SEWAGE DISPOSAL SYSTEM

MARYLAND STATE DEPARTMENT OF HEALTH*

HOWARD COUNTY

PROPERTY OWNER William Johnson P

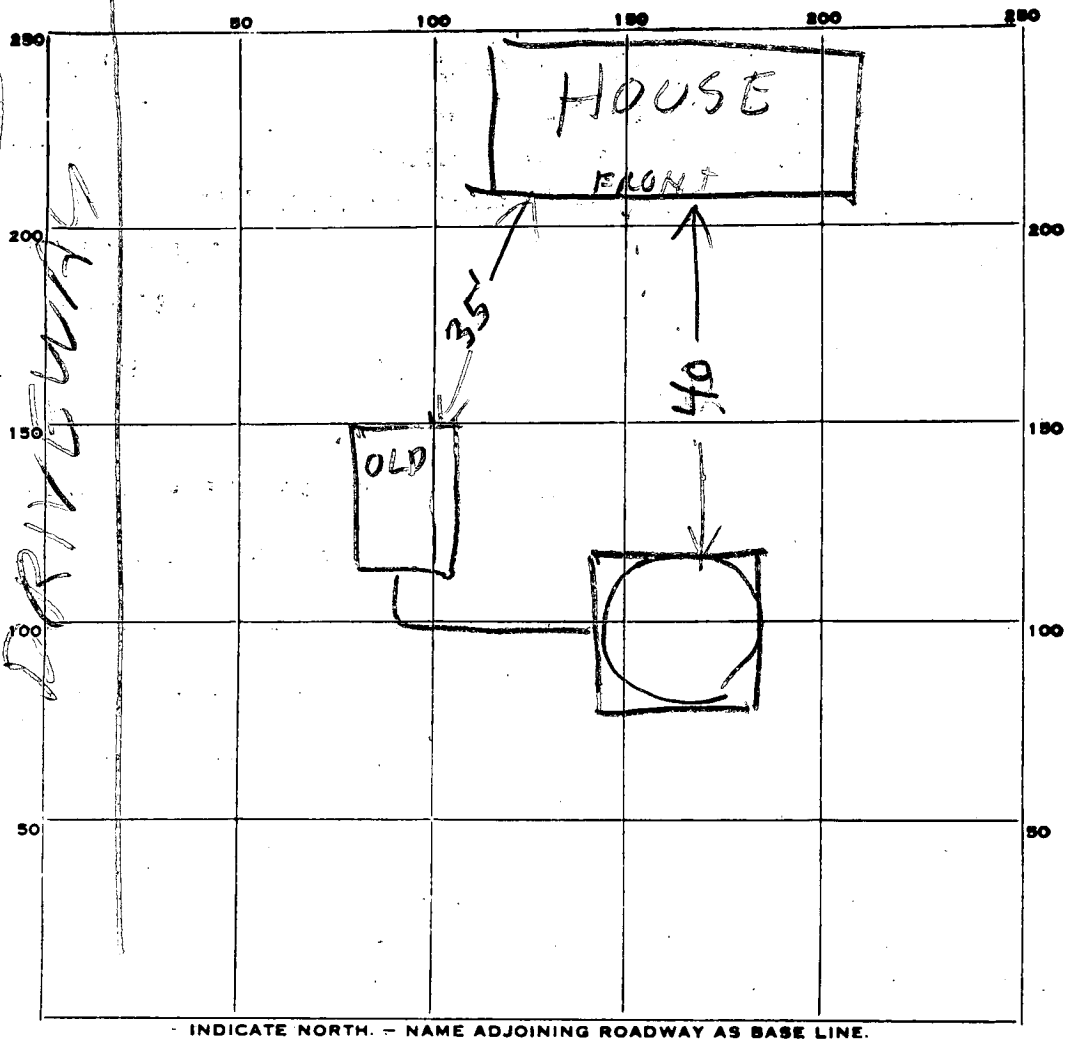
REPAIR DRYWELL - 15x15 feet - Inlet 4ft. to 4 1/2 ft. and Maximum depth 10 1/2 ft. in
hole 1 above ~~dry~~ to limited repair area. 2/29/80

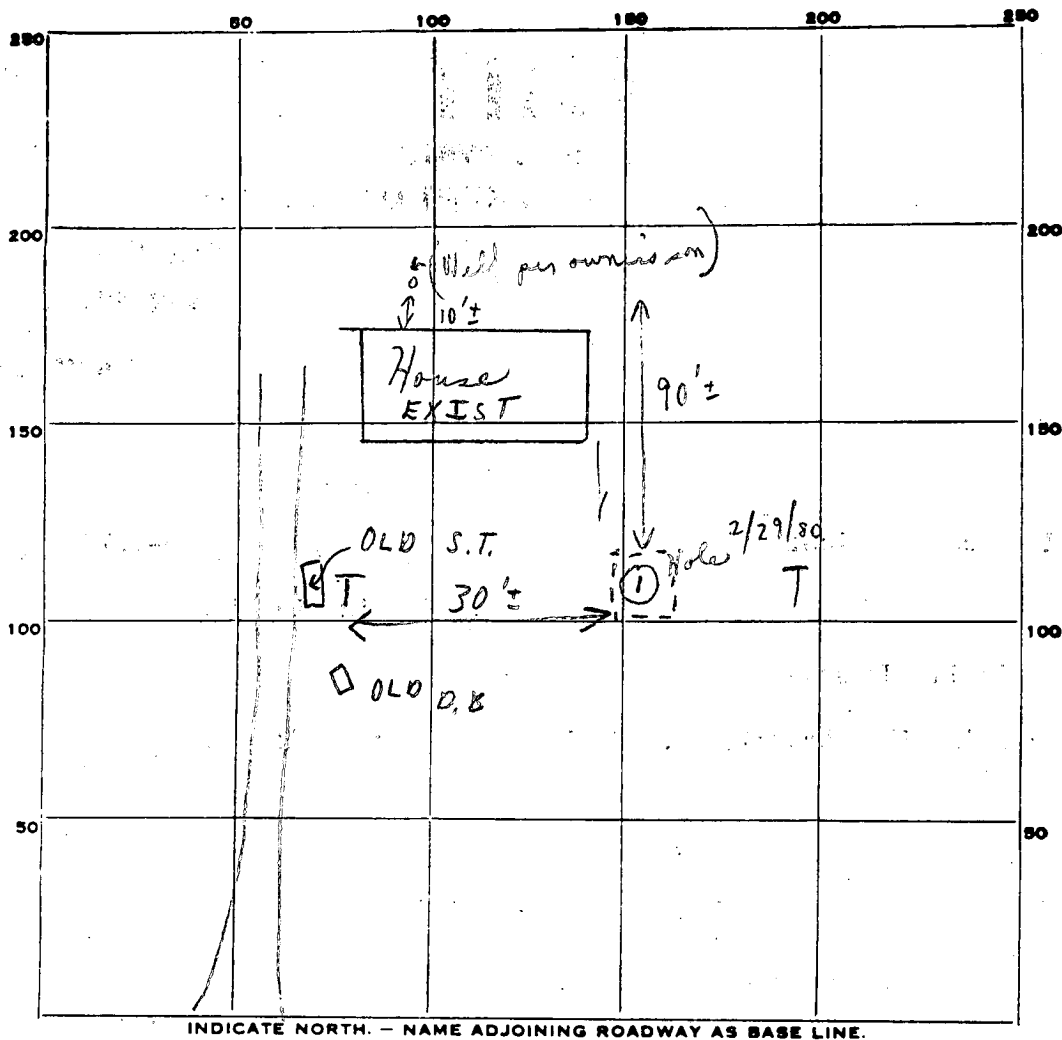
REMARKS 4/3/80 DW INLET 5FT BELOW
GRADE. WELL IN BACK OF HOUSE,
OLD T.F. WORKED 20 YEARS

REMARKS 2/29/80 CHECKED GROUND - DRY WELL 15X15 INLET @ 1' AND MAXIMUM DEPTH 10 1/2' IN HOLE ① ABOVE DUE TO LIMITED REPAIR AREA. [] Future dry well.
